CONDITIONAL APPROVAL OF THE DRAFT WELL INSTALLATION WORK PLAN FOR INTERIM MEASURES PERFORMANCE MONITORING PROGRAM, DATED NOVEMBER 30, 2005, PACIFIC GAS AND ELECTRIC COMPANY, TOPOCK COMPRESSOR STATION, NEEDLES, CALIFORNIA (EPA ID NO. CAT080011729)

SUBJECT: Well Installation Workplan, Floodplain Interim Measure Performance
Monitoring Program, PG&E Topock Compressor Station, Needles,
San Bernardino County, Project No. 22120/540015-48/36-HWMP

Draft Well Installation Work Plan for Interim Measures Performance Monitoring Program, PG&E Topock Compressor Station, Needles, California. Prepared by CH2M Hill. Dated November 30, 2005.

FIGURE 3-2
PROPOSED LOCATIONS FOR
ADDITIONAL GROUNDWATER WELLS
FOR IM PERFORMANCE MONITORING
 WELL INSTALLATION WORK PLAN FOR
 IM PERFORMANCE MONITORING PLAN
 PG&E TOPOCK COMPRESSOR STATION
 NEEDLES, CALIFORNIA

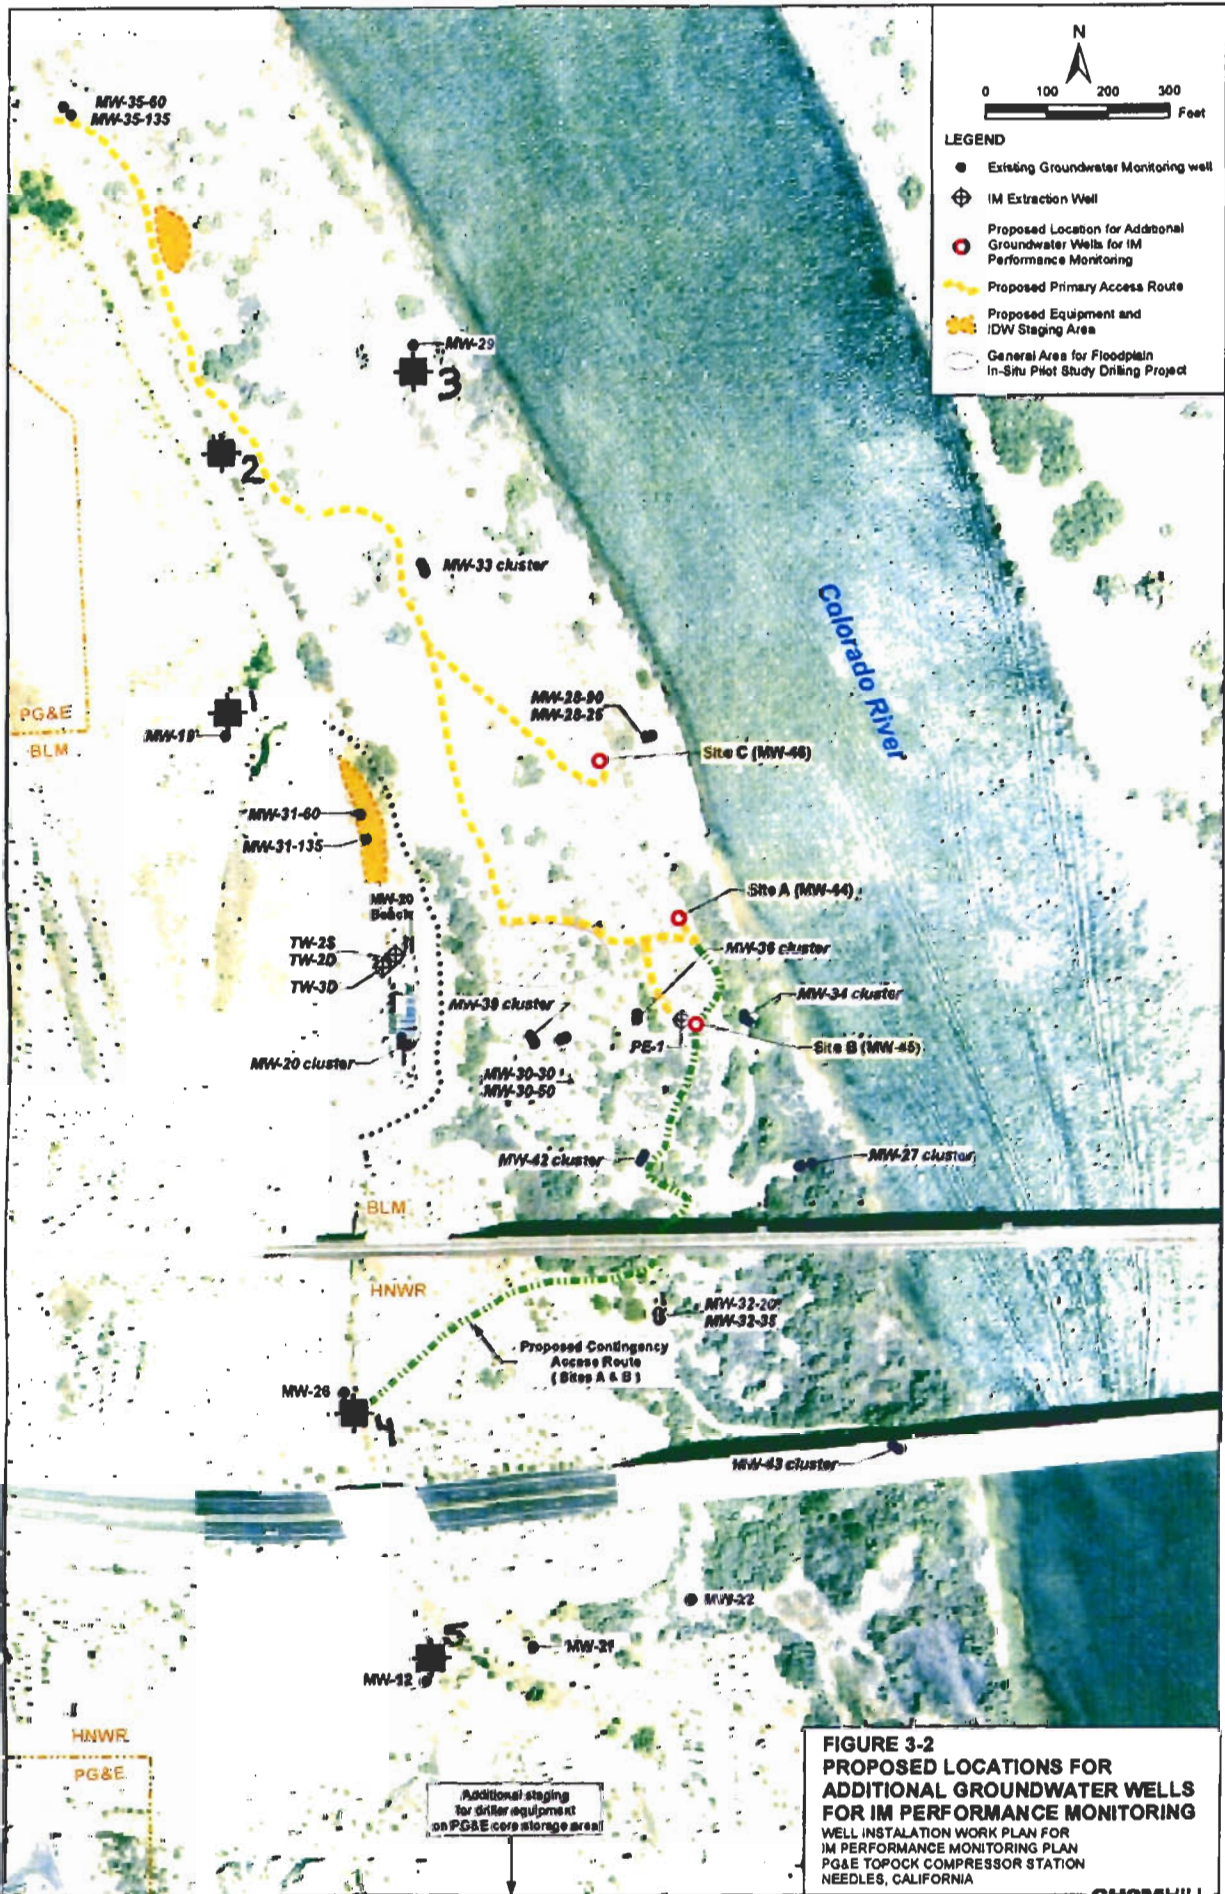
In addition to the scope of work identified in the Workplan, DTSC is also requiring PG&E to install wells at up to five additional locations. These locations are shown on a figure included in Enclosure 1 and consist of four locations and one contingent location. The objective of the additional locations is to acquire data that will:

1. PG&E shall install two wells at Site C rather than the single proposed well. See Comment 2 of Enclosure 1 for further discussion.
2. PG&E is prohibited from using the secondary access route shown on Figure 3-2 of the Workplan as a contingency access route to Site A and Site B drilling locations.

GSU is recommending up to five additional well locations as (1) deeper wells adjacent to an existing shallow well or (2) a new well cluster or well nest. As shown on the attached figure, with the exception of contingent Location 3, the recommended locations lie along Park Moabi Road or are readily accessible from Park Moabi Road. GSU believes that the suggested locations will support important, multiple technical functions (as identified in the above-noted rationale and in the discussion of each location below), without additional disturbance to sensitive upland areas. GSU is making these recommendations without consideration of whether all suggested locations are feasible for this field mobilization. Hence, some locations may need to be deferred as a data collection activity during the Groundwater Corrective Measures Study.

Location 1. Augment existing shallow well location MW-19 by installing middle and deep depth interval wells in the Alluvial Aquifer. This location lies just west of Park Moabi Road and along the road leading to the existing treatment plant. The purpose of this well cluster would be to collect data to address Rationale A, C, D, E, and F (see above).

Location 2. Install a three well cluster or nest along Park Moabi Road, approximately halfway between the MW-31 and MW-35 well clusters. The purpose of this well cluster or nest would be to collect data to address Rationale A, B, C, D, E, and F (see above).

- Location 3. Contingent location. Replace or augment existing well MW-29 (shallow depth interval well in Alluvial Aquifer) with a well cluster or nest that screens multiple zones in the Alluvial Aquifer. A decision as to whether this location is needed should be contingent upon the findings at the Location 2 and potentially Site C. The purpose of this well cluster would be to collect data to address Rationale A, B, C, and E (see above).

- Location 4. Augment existing well location MW-26 (screens shallow depth interval of Alluvial Aquifer) with one or two additional wells screened in the lower portion of the Alluvial Aquifer and upper bedrock (if permeable zones are determined to be present). This location is on Havasu National Wildlife Refuge property and lies along Park Moabi Road. Over the past several years, CWG members have discussed this location as a desirable for both a monitoring well cluster (or nested well pair) and as a potential extraction well location (e.g., PE-2). The purpose of this well cluster would be to collect data to address Rationale A, B, C, and D (see above).

- Location 5. Install a shallow bedrock well adjacent to monitoring well MW-12 which screens the saturated portion of the Alluvial Aquifer (approximately 25 to 47 feet below ground surface) and the reported top of the red fanglomerate (approximately 47 to 50 feet below ground surface). This location lies in a low-lying area immediately west of Park Moabi Road and is on Havasu National Wildlife Refuge property. The purpose of this additional well would be to collect data to address Rationale A, B, C, E and F (see above).

4. PG&E shall install at least two new monitoring wells at Location 1, adjacent to existing well MW-19. At least one well shall be installed with a larger diameter casing that is capable of supporting hydraulic testing.

5. PG&E shall install at least three new monitoring wells at Location 2, along Park Moabi Road and approximately midway between the existing MW-31 and MW-35 well clusters. The design of this well cluster shall be capable of support hydraulic testing.

6. If determined to be necessary by DTSC, upon reviewing field results observed at Location 2 or Site C, PG&E shall be prepared to install a well cluster at Location 3 to augment or replace existing well MW-29.

7. At Location 4, PG&E shall advance a boring adjacent to existing well MW-26 to verify the depth of the fanglomerate bedrock and shall use the same investigation

8. At Location 5, PG&E shall drill adjacent to existing well MW-12 to verify the depth of the fanglomerate bedrock and shall use the same investigation techniques as described in the Workplan (i.e., drilling method, continuous logging, Isoflow® sampling). If a sufficient thickness of saturated Alluvial Aquifer and fanglomerate is encountered below the MW-12 screen interval (i.e., five to ten feet), PG&E shall be prepared to install a new monitoring well to monitor that zone. As feasible, the borehole shall penetrate several feet into the fanglomerate unit to determine whether a water-bearing zone is present. If determined to be present, PG&E shall include installation of a bedrock well at this location as a future data collection activity in the Groundwater Corrective Measures Study Workplan.
